Access Compliance Report Public Rights-of-Way (Curb Ramps)

Intersection ID: 20050 Main Street: SARDIS_RD Cross Street: CHEVRON_DR Location: NE

ADA ID: B2EFA41E9524 Ramp Type: PerpDiag Initial Pass/Fail: Fail Overall Compliance: No Severity Score: 12.5

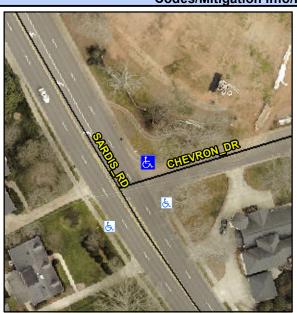
Not Found, R304.2.2

Remove & Replace Curb Ramp With Two New Directional Ramps or Equivalent.
